Deck Repair

2923 S. MERIDIAN ST (BLDG J) SITE ADDRESS: PUYALLUP, WA

## (Construction Plans, Sheet A1.1)

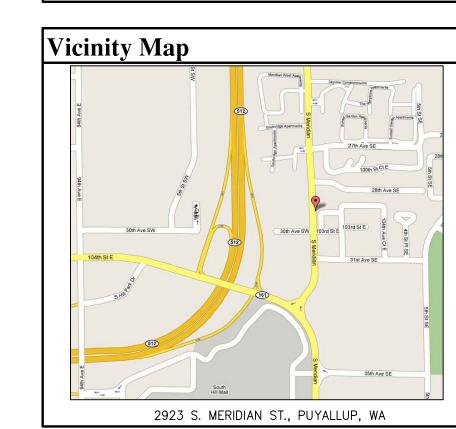
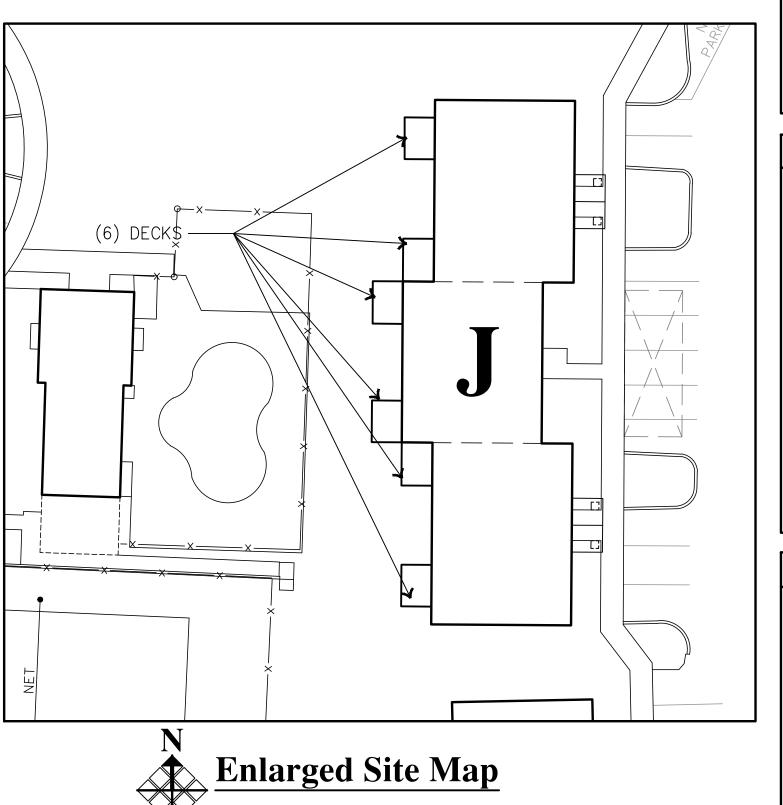
Provide specifics of the plywood that will be installed which should include plywood thickness, grade and any other specifics that will reflect that the plywood will withstand the dead and live loads of the deck. Identify the non-slip surface that will either be provided on the plywood or will be added to the plywood as part of construction, as notated on sheet A1.0, Owner/Contractor Coordination Notes.

The existing joist spacing should also be considered when selecting the plywood material that will be used. Please provide the existing joist spacing.

Determine the minimum required specifications for deck beams, posts, post bases, post caps and footings if replacements are necessary. Given the work already completed and the stop-work order in place, establish a clear benchmark to assess the completed work and provide clarity for future construction and inspection, minimizing any potential ambiguities.

Deck joists appear to be sloped to drain off of the cantilevered side of each deck based upon details 1 and 2. Detail 2 shows the installation of the 1x6 cedar board over the existing 2x2 balusters. detail or notate how the 1x6 cedar will be installed to prevent drainage and water accumulation on the deck surface.

Add a notation on either Sheet A1.0 or A1.1 that contractor shall verify the integrity of balusters prior to the installation of the 1x6 cedar. Establish the parameters of the balusters replacement to include type, grade and nailing pattern.

Updated all details and notes as needed to reflect the requested information.
